# CABINET MEMBER FOR ENVIRONMENT – 27 APRIL 2017 PROPOSED SHARED USE CYCLE TRACK- B481 AT SONNING COMMON

#### **Report by Director for Infrastructure Delivery**

1. This report presents responses received in the course of a consultation on a proposal to convert an existing footway adjacent to the B481 at Sonning Common to shared use footway/cycletrack.

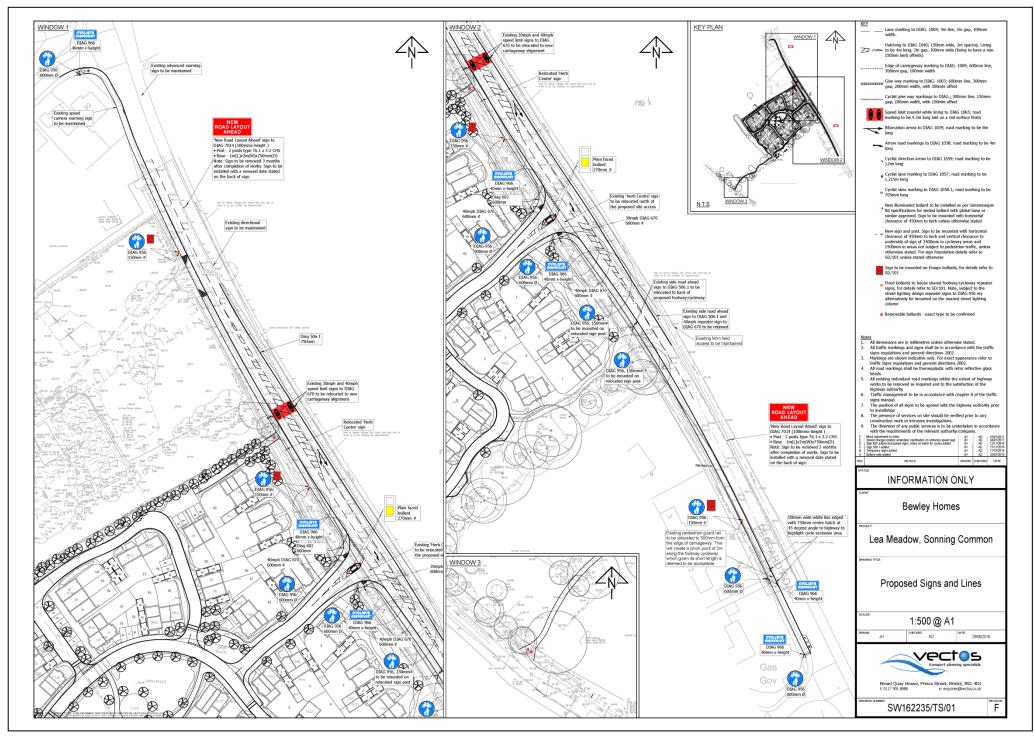
- 6. Thames Valley Police raised no objection, but noted that the facility was isolated from any other provision for cyclists, and commented that this might lead to cyclists using the adjacent footways. The police response also noted that the consultation plan showed an amendment to the speed limit in the vicinity, for which no consultation had been received.

- 9. One objection was received from a resident of Westleigh Drive on the grounds of a lack of usage by cyclists (although it was accepted that the footway required upgrading) and that the proposed cycle track was not acceptable on the grounds of pinch points at two locations, the lack of clarity on the proposed demarcation proposed and also the source of funding not being specified.

- 10. A further objection was received from a local representative of Cycling UK, on the grounds that the design of the cycle track was inadequate, and would not provide an adequate facility for cyclists.

RESPONDENT	SUMMARISED COMMENTS
(1) Thames Valley Police	I have visited the location. The new development I note is situated on the southern outskirts of Sonning Common village. From the drawing and from what I witnessed on site the proposed shared use facilities appear very isolated from the rest of the village and I see no justification or need.  They do not appear to link in with any other cycle infrastructure and I fear they could encourage greater cycling on the foot way in other parts of the village.  I am also slightly confused by mention of the current speed limit signing or should I assume in due course you will be consulting on a speed limit alteration as well.

(6) Resident, (Westleigh Drive)	<ul> <li>Your definition of "Footway" should be Footpath as it is not used as a Carriageway.</li> <li>Plan does not detail whether change is to be segregated or unsegregated.</li> <li>Conversion of footpath is not viable as it is used by less than 10 cyclists a day, although the footpath does need up grading due to the large amount of elderly residents walking to the Millennium Green.</li> <li>Width of footpath from Herb Centre to Westleigh Drive not sufficient to accommodate both pedestrians and cyclists. Dept: of Transport recommend a minimum of 3 metres, at one pinch-point the width is 1.8 metres narrowing to 1.6 metres in Westleigh Drive</li> <li>No indication has been given as to who is going to pay for the work involved, as I believe, this was included in the original planning application it should be Bewley Homes who pay for the work and not the Council.</li> </ul>

(9) Cycling UK campaigner	The facilities for cycling, as added to this proposed development, are entirely inadequate. They inappropriate, incoherent, uncomfortable, bitty, full of 'cyclists dismount' signs, and in all are approaching no more than a tokenistic response to a demand to enable cycling to be a transport choice.  I object to these incoherent and faulty designs

- 11. The responses of Sonning Common Parish Council and the local member are noted. The demarcation of the shared use track is as shown at Annex 1, and comprises the use of the signs in accordance with the Department for Transport guidance, and also the use of tactile paving. The maintenance of the track will be the responsibility of the County Council. The response of South Oxfordshire District Council is also noted and it is confirmed that the provision of the track will not impair any aspect of the operation of the new junction.

- 12. Thames Valley Police's concern that the proposed cycle track is not linked to other cycle provision is noted. However the development provides the opportunity for providing a safe route for cyclists that should encourage cycling to and from the new housing to village amenities, and potentially could be extended in the future to serve longer cycle trips. Experience of other locations where shared use cycle tracks are not continuous does not suggest that there is an undue risk of cyclists continuing to cycle on the adjacent footways. On the query on the possible speed limit change as shown at Annex 1, it is confirmed that no change is being progressed at this time.

- 14. The objections from the member of the public on various technical grounds (as summarised at Annex 2) are not based on a correct understanding of the legal status of the existing provision for pedestrians (which is a footway) and Annex 1 shows the demarcation of the proposed shared use provision; there is also no minimum threshold of use by cyclists, and one of the objectives of the provision is to facilitate new cycle trips by residents of the proposed development.

- 15. The objection from a local representative of Cycling UK focusses on a concern that the proposed provision is 'tokenistic'. It is accepted that the scope of the proposal is limited to the vicinity of the development site, and as such will only benefit a relatively small number of local cycle trips. However, this is still judged to be useful from a local transport perspective and in particular for trips by less confident cyclists including children, and there is the potential for the provision to be extended in the future. It is however accepted that some elements of the proposed design and specifically the extensive use of 'cyclist dismount' signs should be reviewed in accordance with national guidance on cycle infrastructure.
